**ROCKY MOUNTAIN ARSENAL**

FINAL  
TECHNICAL PLAN  
VERSION 3.1

TASK NO. 10  
SEWERS AND PROCESS WATER SYSTEM INVESTIGATIONS

TASK NO. 10  
SEWERS AND PROCESS WATER SYSTEM INVESTIGATIONS

**FIGURE 3.4-7**  
**Investigative Program South Plants**  
**Sanitary Sewer System**

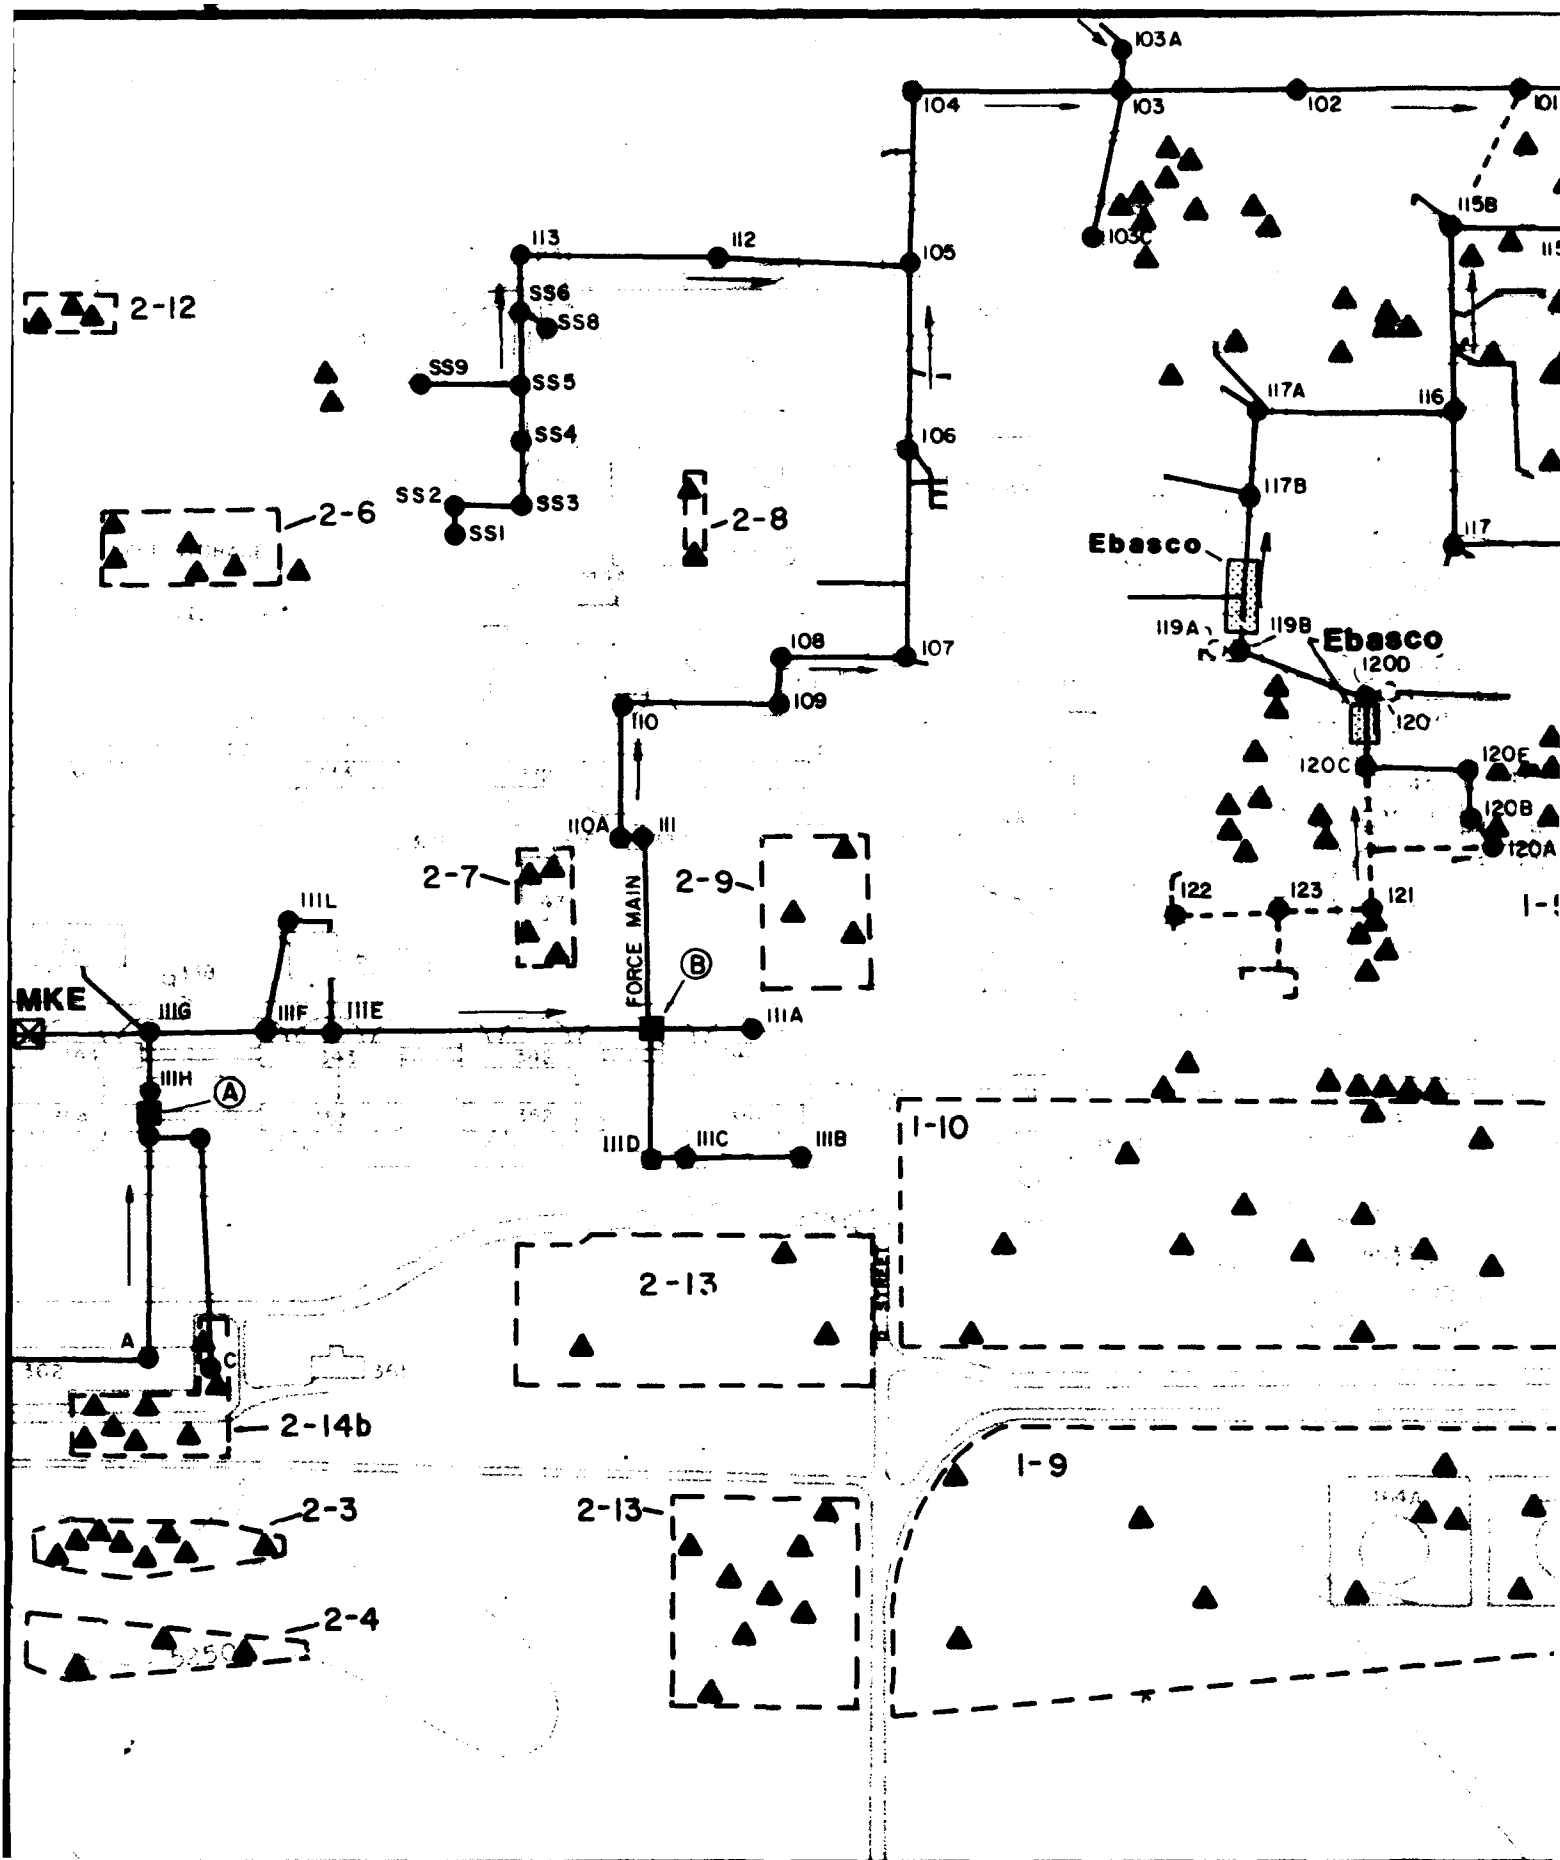
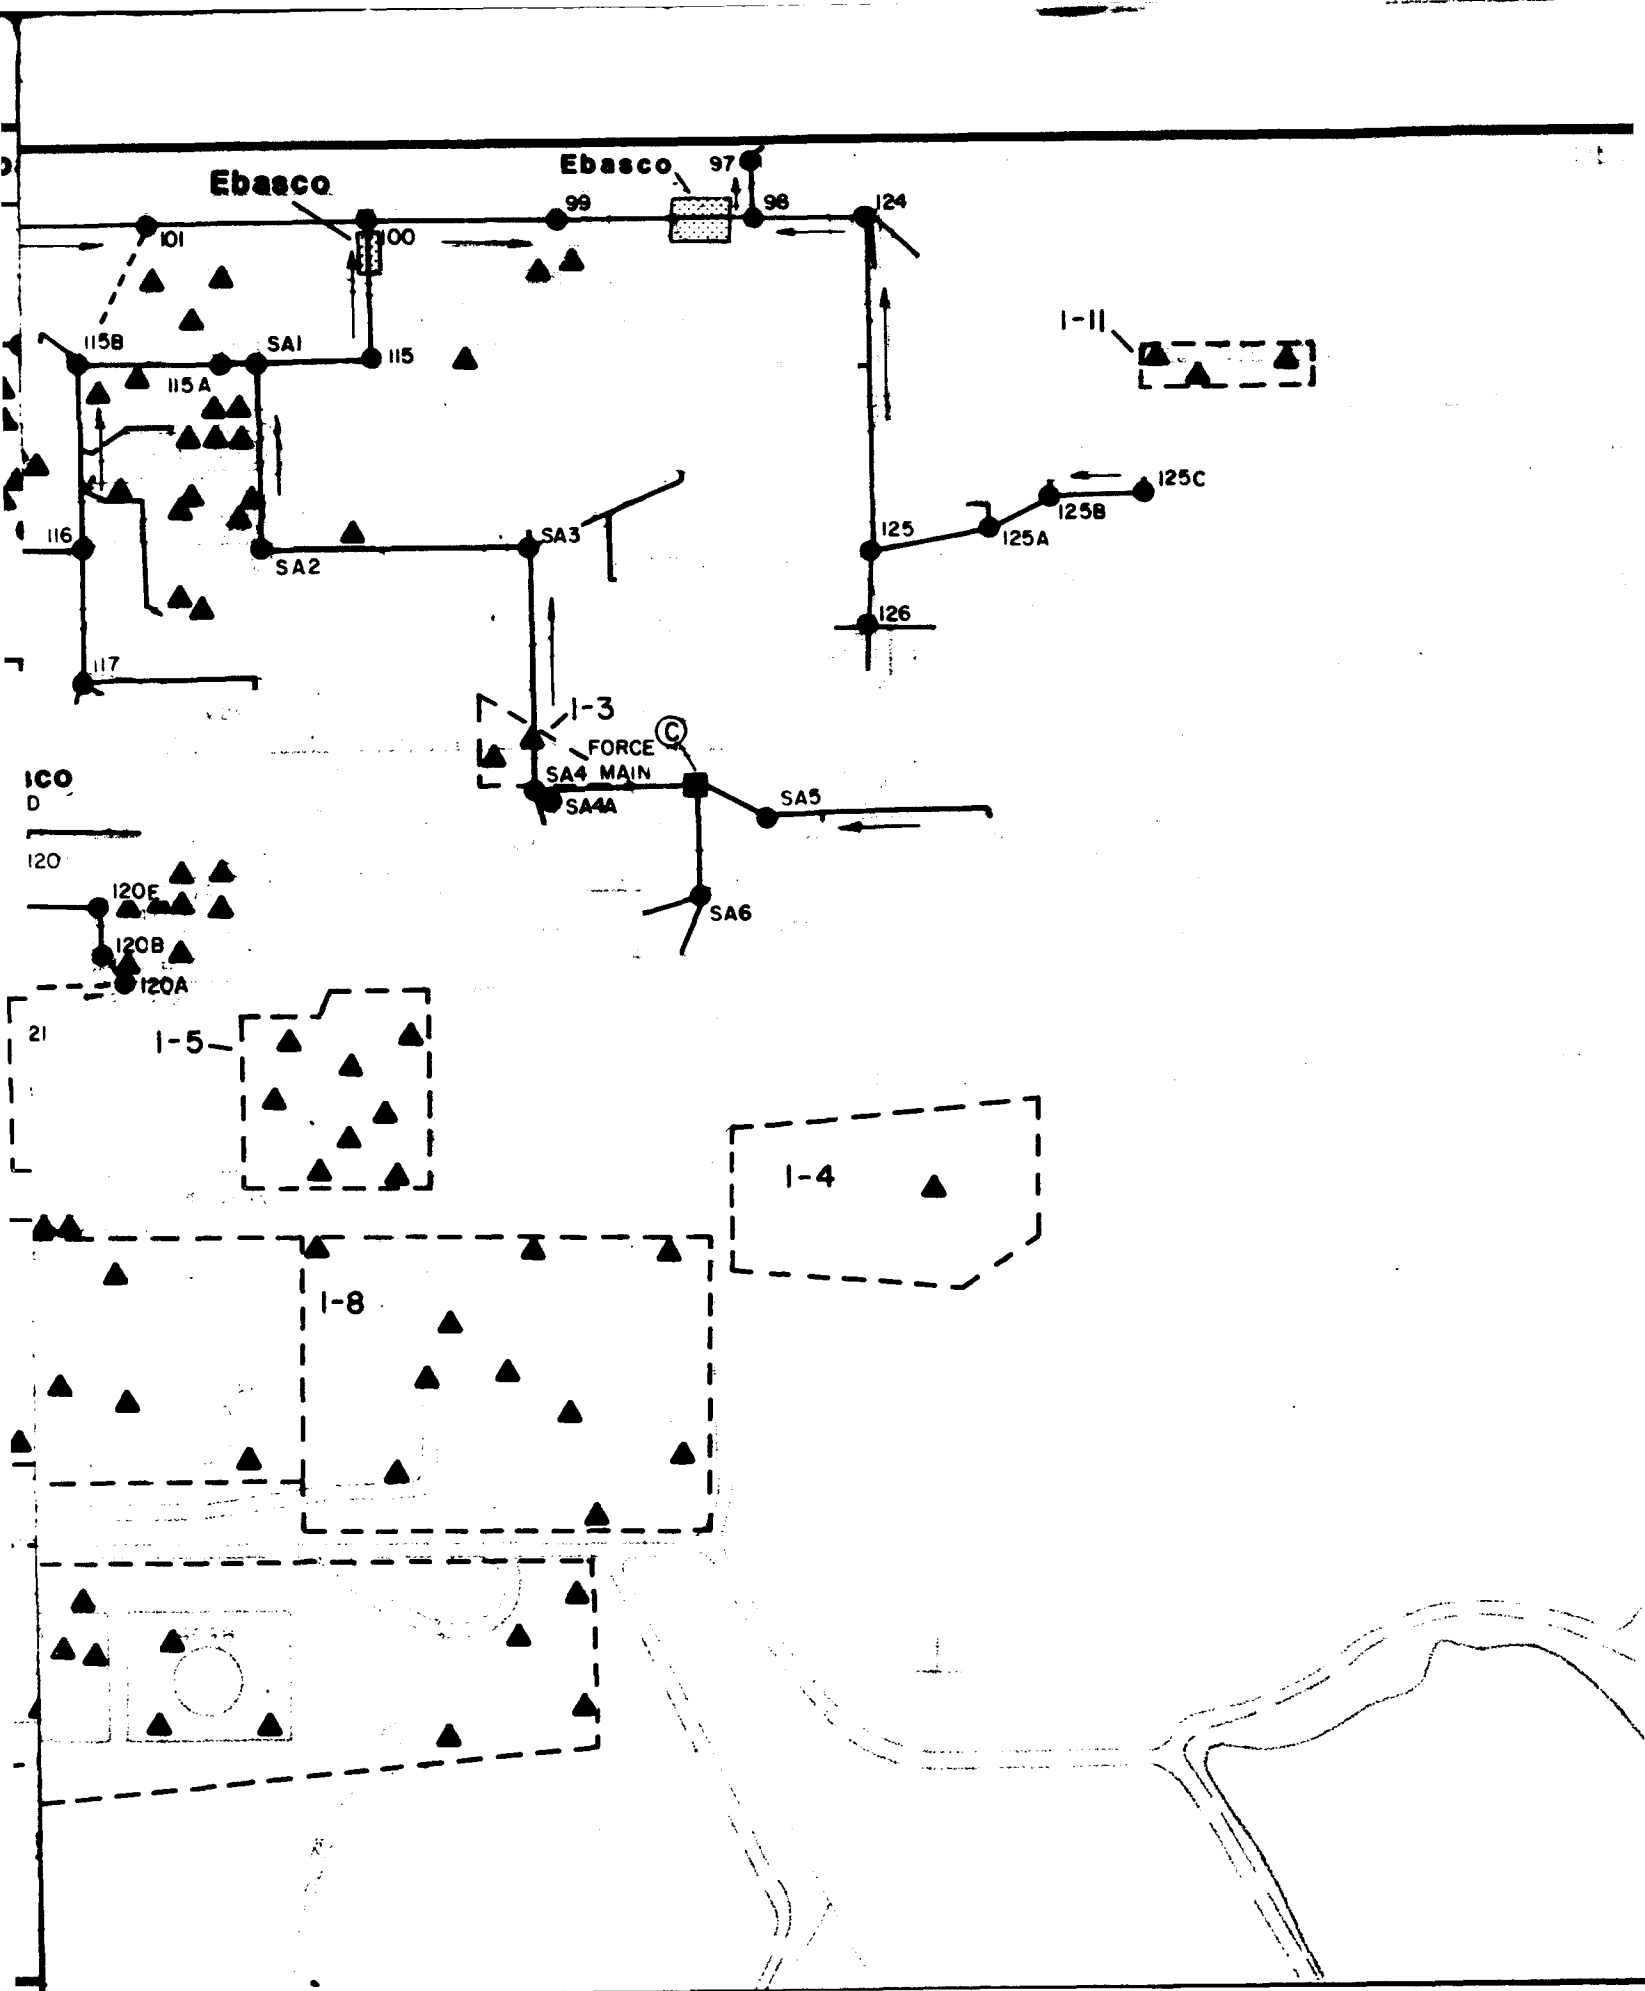
17. Comment: Page 3-29, second paragraph, and Figure 3.4-7.  
The two sanitary sewer sites proposed for dye/excavation study may prove to be difficult. The site between Manholes 117B and 119B is in line with an above ground steam line that will interfere with excavation, and the site between Manholes 98 and 99 will either be below the groundwater table or very close to it.

18. Comment: Table 3.4-2, Page 3-30, and Figure 3.4-7.  
The bottoms of Manholes 97, 98, 99, 100, 124 and possibly 125 have been under groundwater historically and probably are presently either below the water table or close to it. As stated on page 3-35 of the Technical Plan, Section 36 sanitary sewer manholes are not to be sampled due to the difficulty of determining the source of contamination in soils contacted by contaminated groundwater. If this is true, the same rationale should be applied to the South Plants manholes in close proximity to the contaminated groundwater mound.
